**SAN LEANDRO SENIOR CENTER - PHASE 2  
PROJECT NO. 06-210-18-116**

**ADDENDUM NO. 3**

July 16, 2008

ADDENDUM 3  
 REVISION  
 AD3-1/A5.1-01  
 DRAWING

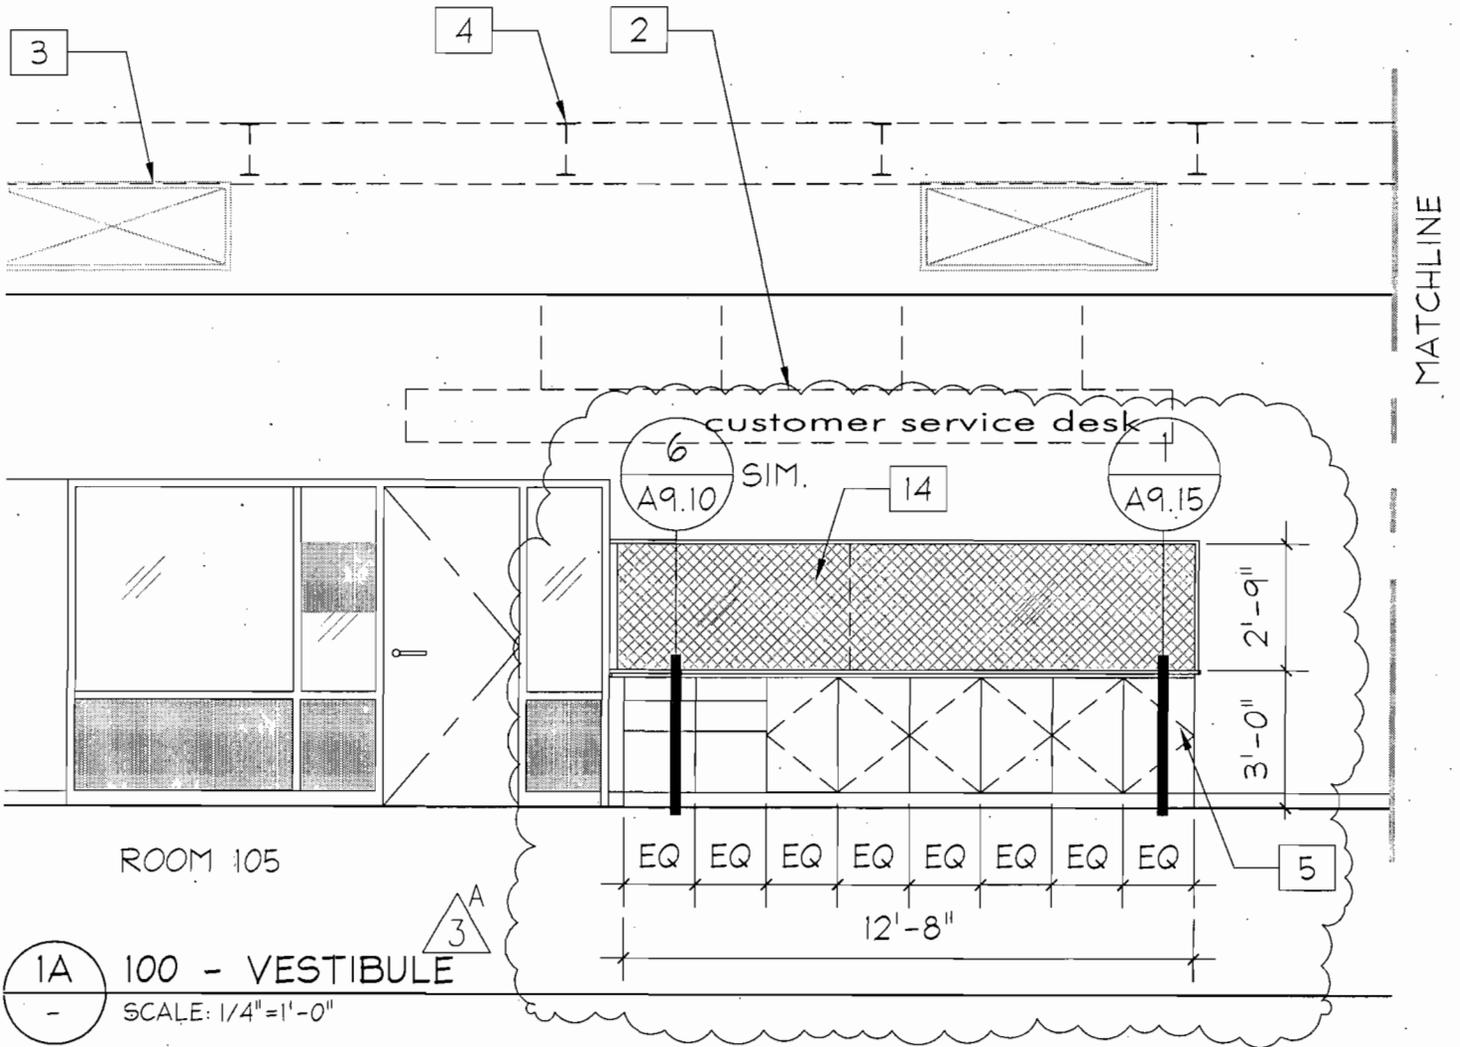
- D-15. Sheet A5.1 Interior Elevations:  
Sketch AD3-1/A5.1-01: REVISE Casework layout and detail callouts.
- D-16. Sheet A5.2 Interior Elevations:  
Sketch AD3-A5.2-01: REVISE detail 1A, add (2) Wall Display Casework for LEED Educational Signage as shown on detail 2/G2.5. REVISE detail 2B, casework dimensions.

AD3-A8.0-01

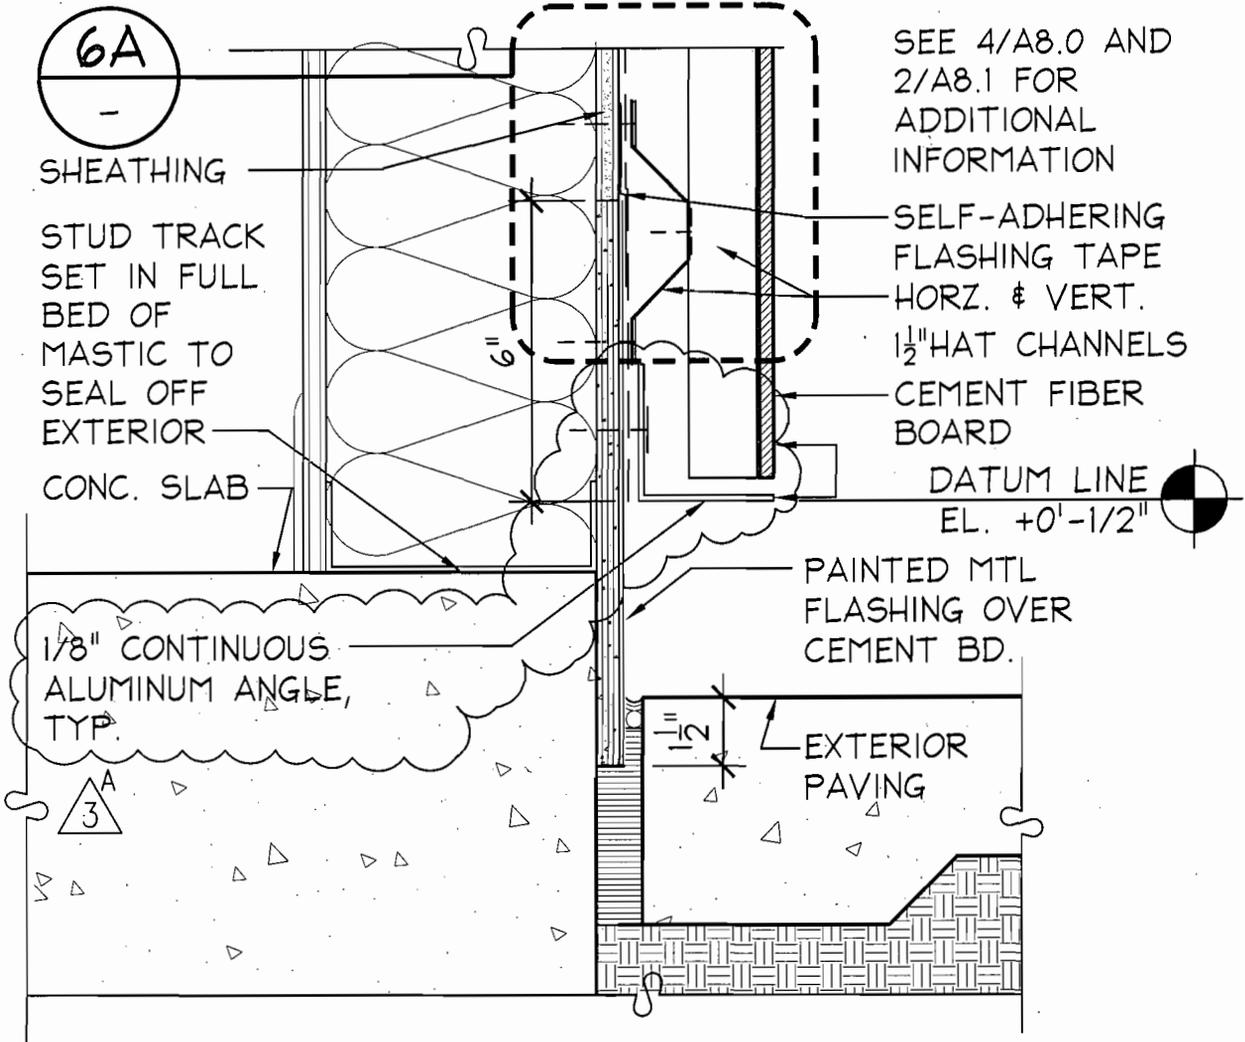
- D-19. Sheet A6.1 Low Roof Reflected Ceiling Plan:  
REVISE detail (3) callouts for Access Roof Hatch from 9/A9.5 to 7/A8.12. No sketch issued.
- D-20. Sheet A8.0 Exterior Wall Details & Exterior Wall Types:  
Sketch AD3-A8.0-01: ADD Underlayment Notes for the various exterior finishes.

A8.9 EXTERIOR & ROOF DETAILS  
BASE OF WALL AT CEMENT BOARD  
SHEET TITLE  
07-14-2008  
DATE  
PA  
BY  
ADDENDUM 3  
REVISION  
AD3-6/A8.9-01  
DRAWING

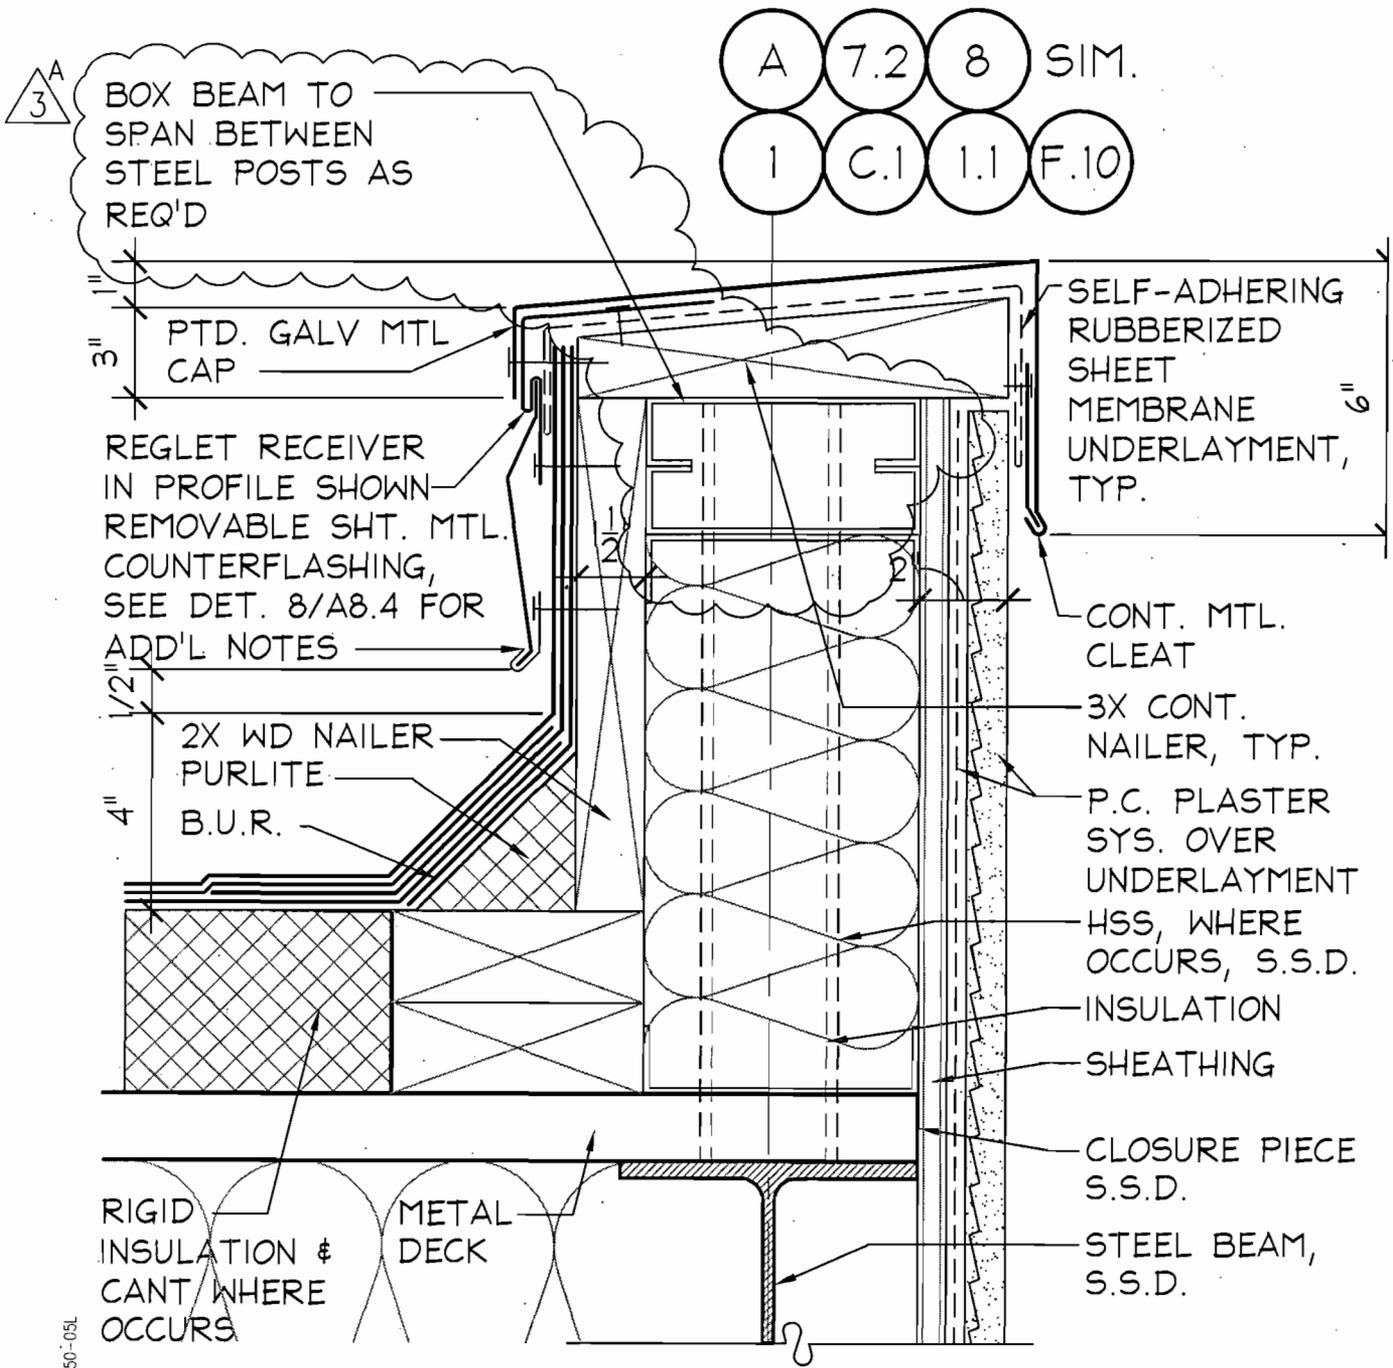
- D-21. Sheet A8.1 Exterior Details:  
ADD to note Ventilation/ Insect Screen “Typical, at top of open cavity application”. No sketch issued.
- D-22. Sheet A8.9 Exterior and Roof Details:  
Sketch AD3-6/A8.9-01: ADD 1/8” thick aluminum angle, typical at wall base.

A8.10 EXTERIOR ROOF DETAILS  
 SHEET TITLE  
 07-14-2008  
 DATE  
 PA  
 BY  
 ADDENDUM 3  
 REVISION  
 AD3- 5/A8.10-01  
 DRAWING

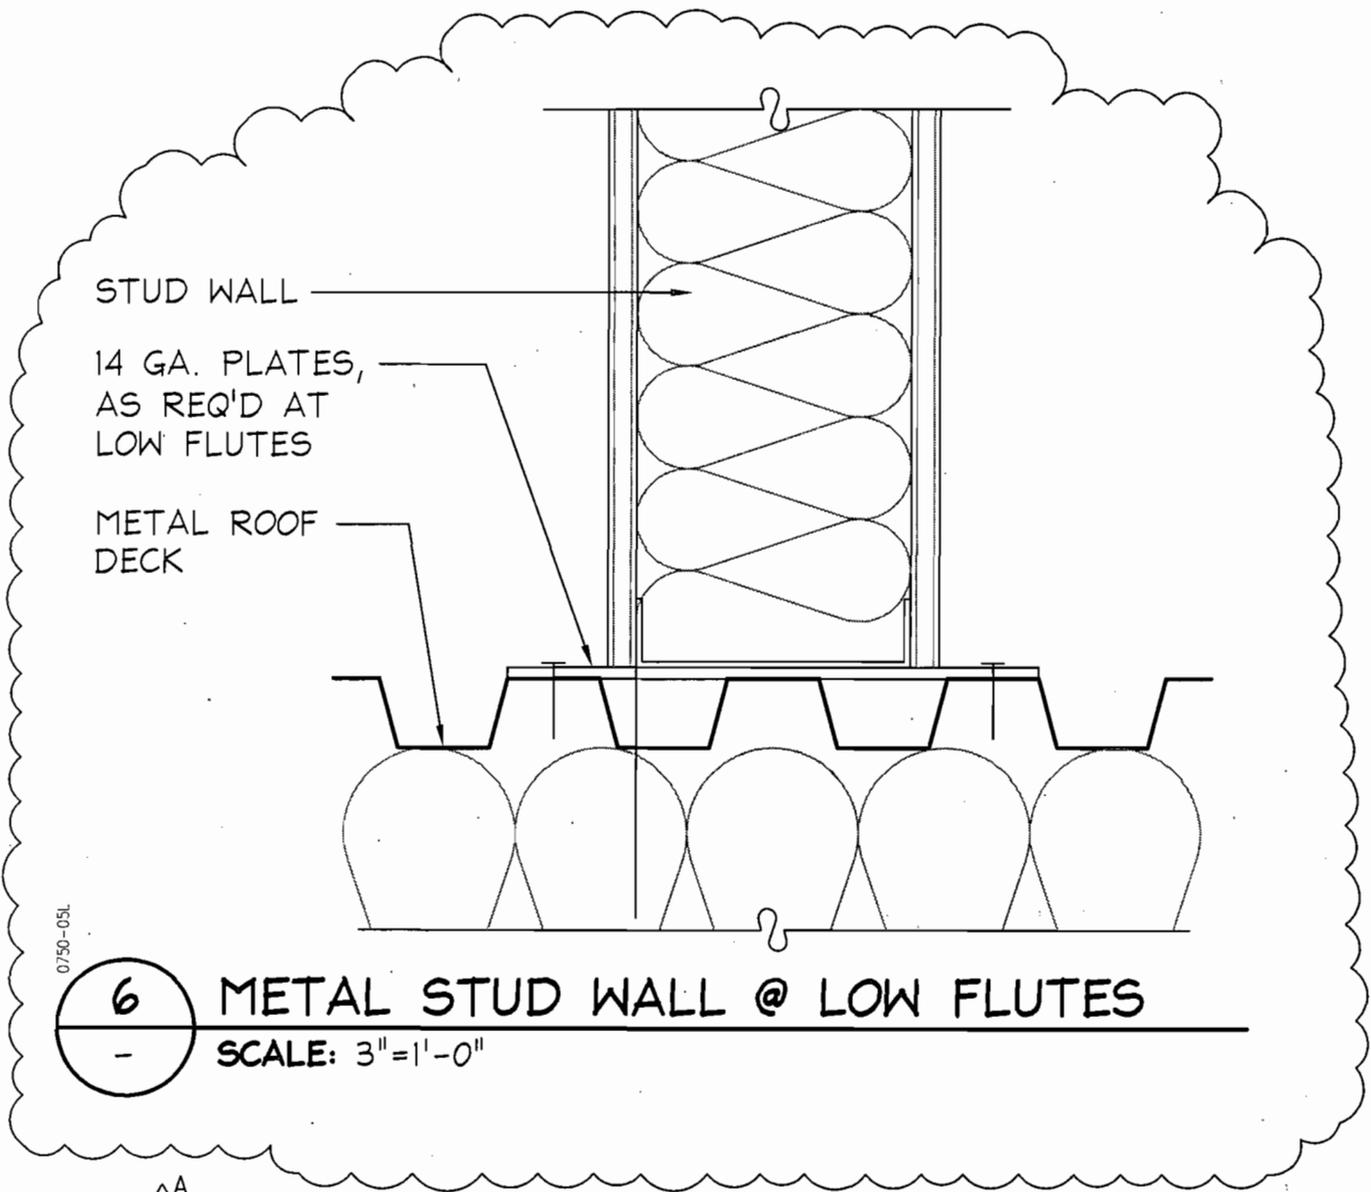
- D-23. Sheet A8.10 Exterior and Roof Details:  
Sketch AD3-5/A8.10-01: REVISE detail 5, Indicate box beam at parapet support.
- D-24. Sheet A8.10 Exterior and Roof Details:  
Sketch AD3-6/A8.10-01: ADD new detail 6, Metal Stud Wall at Low Flutes.

ADDENDUM 3  
REVISION  
AD3- 1A/A8.12-01  
DRAWING

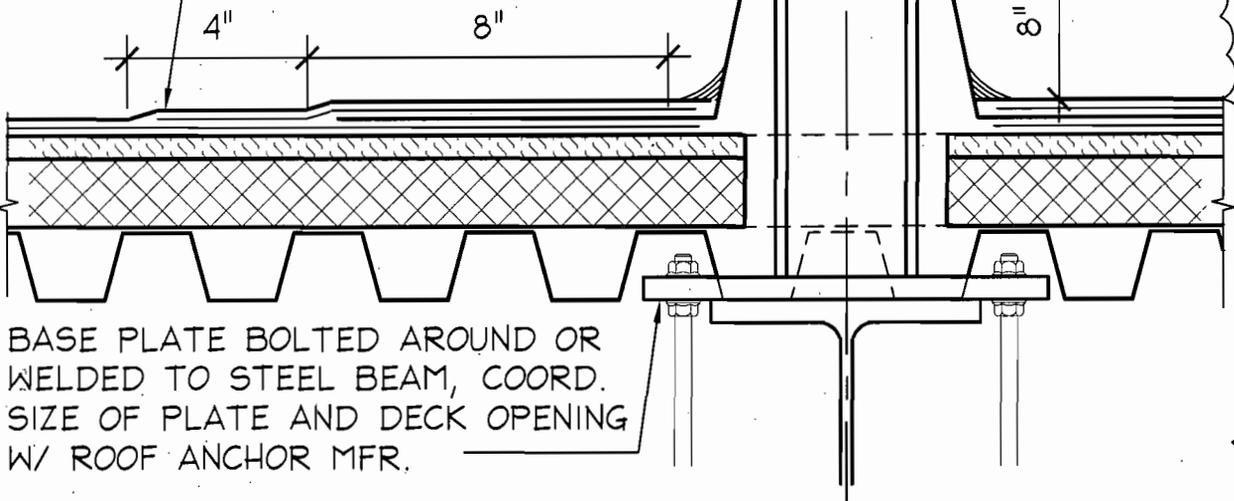
- D-25. Sheet A8.12 Exterior and Roof Details:  
Sketch AD3-1A/A8.12-01: REVISE detail 1A, Fall Protection Roof Anchor.
- D-26. Sheet A8.12 Exterior and Roof Details:  
Sketch AD3-3/A8.12-01: REVISE detail 3, Duct Support Flashing.

Q-41. Section 11015 requires us to perform the impossible. Section 11015-2, 1.5, A requires the design in accordance with plans. Section 11015, 1.5, D requires design of anchors to resist a pull out force of 5400 lbs. The detail 1A/A8.12 on the plans cannot achieve the design loads. At a minimum the fall protection anchors would have to be properly anchored to the metal decking, but most likely will require attachment to the structural steel roof beams in order to resist the 5400 lbs of pull-out force. If details which can achieve the design loads are not provided (by Addendum) we will assume a change order will be authorized for the additional cost for any additional structural steel necessary to meet the design load requirements.

Response: See Drawing Change D-25 of this Addendum, detail 1A/A8.12 has been revised to indicate fall protection anchor bolted to steel beam.

ADDENDUM 3  
 REVISION  
 AD3-3/A8.12-01  
 DRAWING

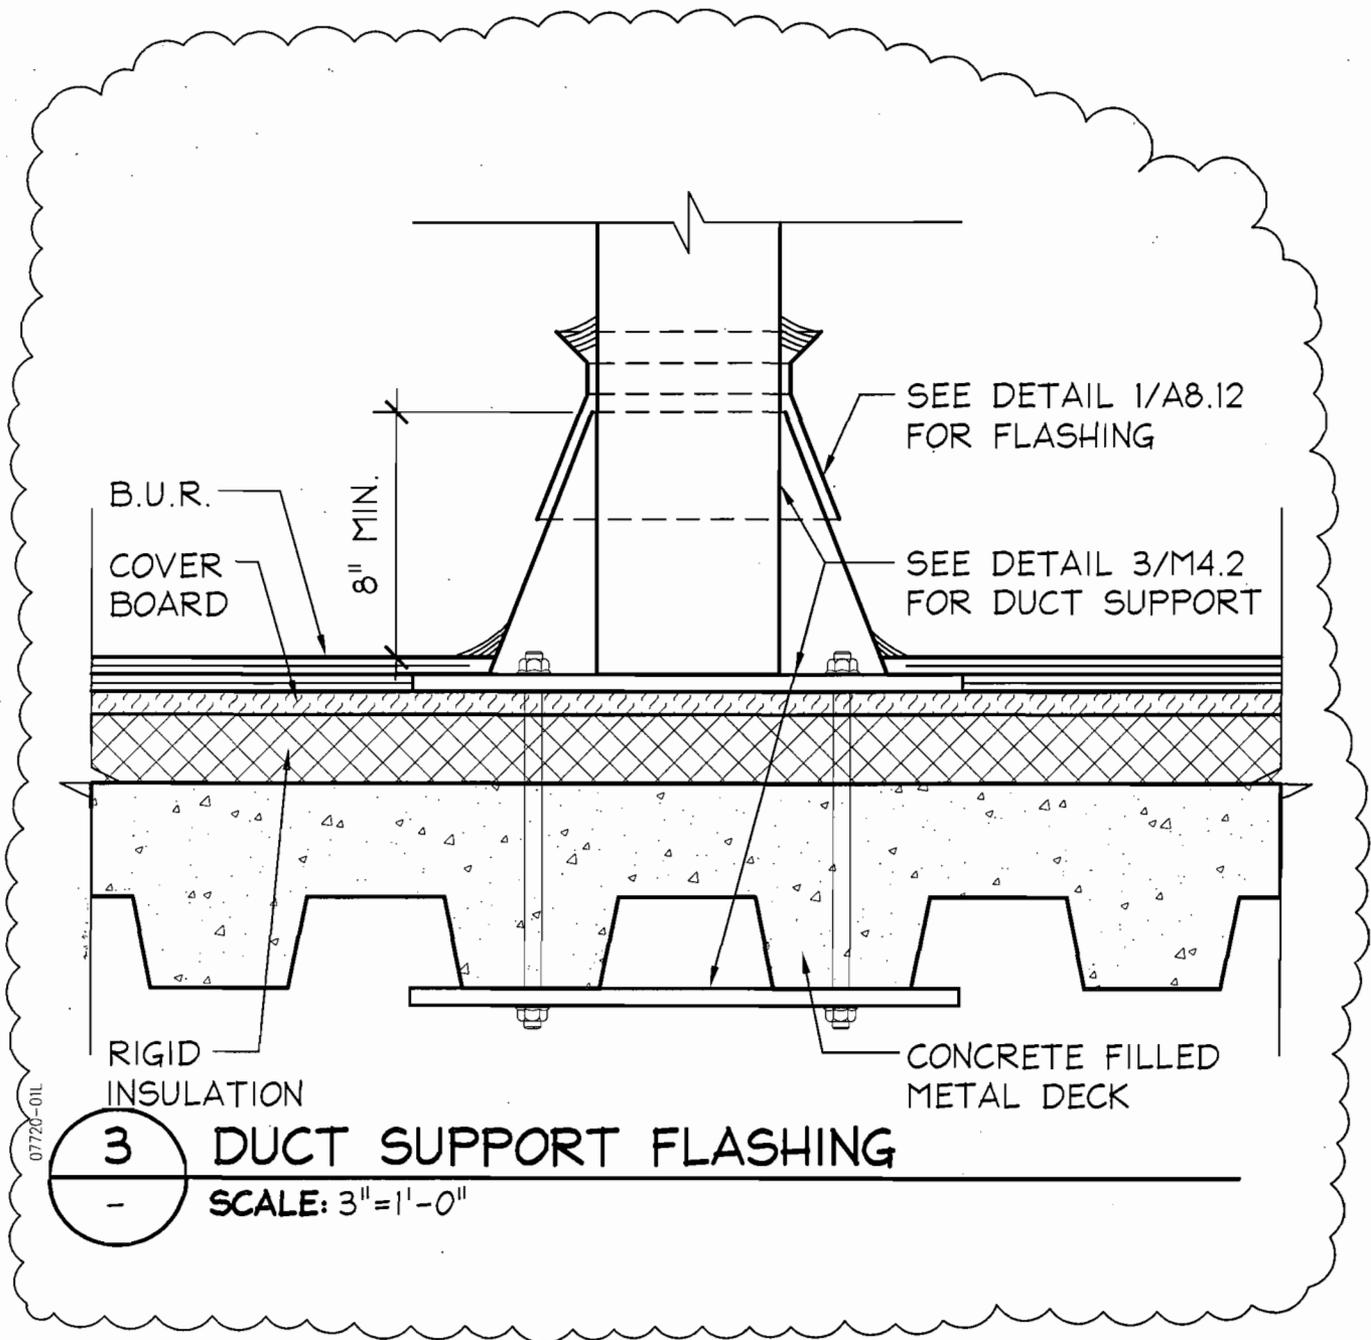
- Q-1. Duct support details conflict between Architectural 3/A8.12 versus 3/M4.2. Which of these two different details will we be required to use?  
Response: Detail 3/A8.12 indicates Duct Support Flashing, refer to Drawing Change D-26. Detail 3/M4.2 indicates Duct Supports.

ADDENDUM 3  
REVISION  
AD3-5/A8.13-01  
DRAWING

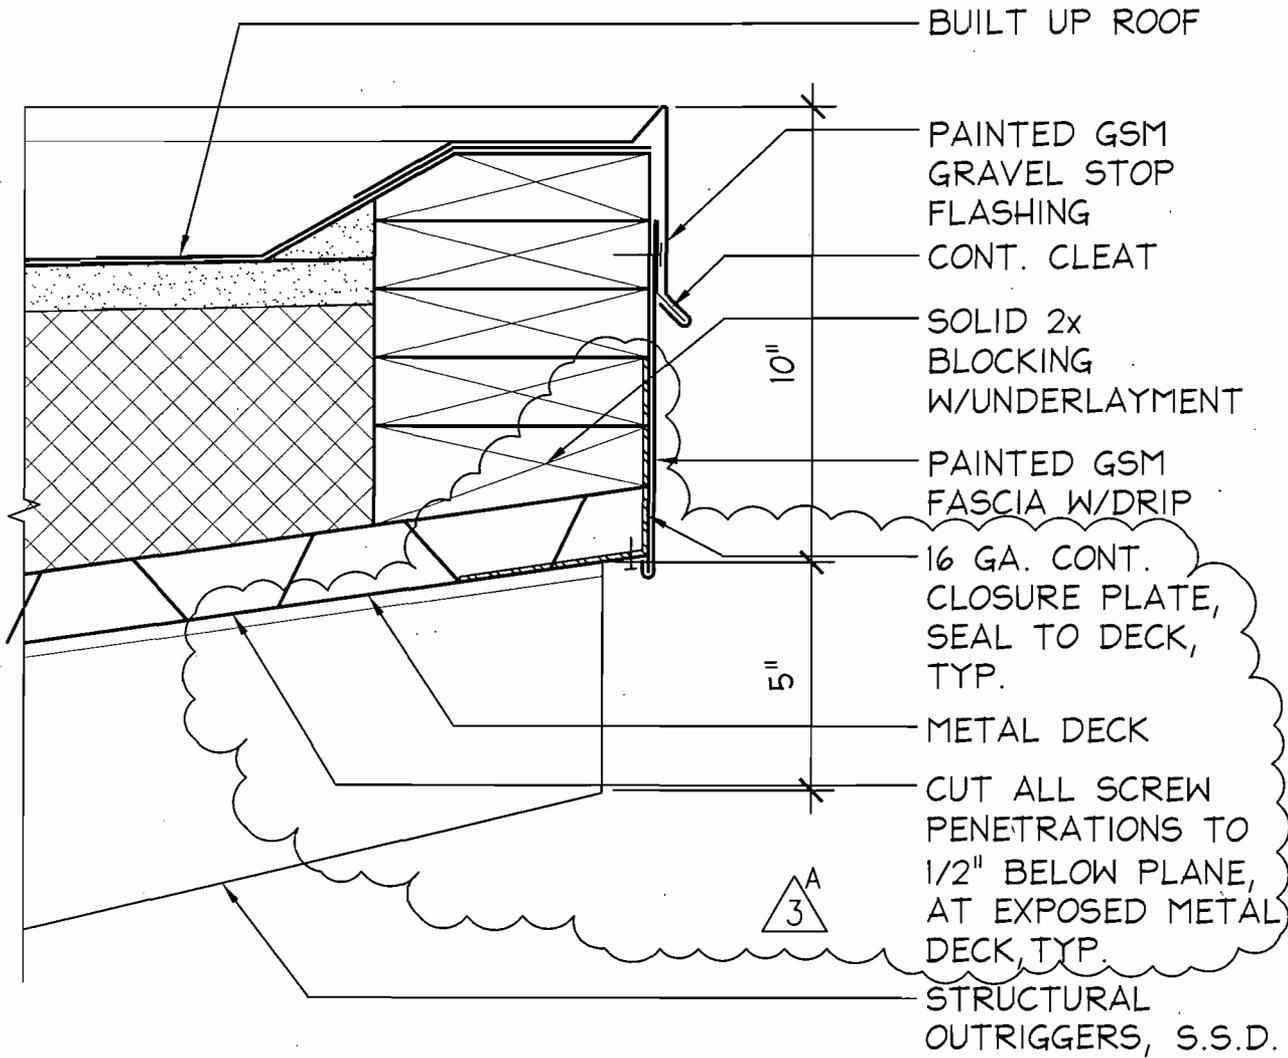
- D-27. Sheet A8.12 Exterior and Roof Details:  
Sketch AD3-7/A8.12-01: REVISE detail 7, Indicate ceiling edge condition.
- D-28. Sheet A8.13 Exterior and Roof Details:  
Sketch AD3-5/A8.13-01: REVISE detail 5, Add Closure Plate and notes.
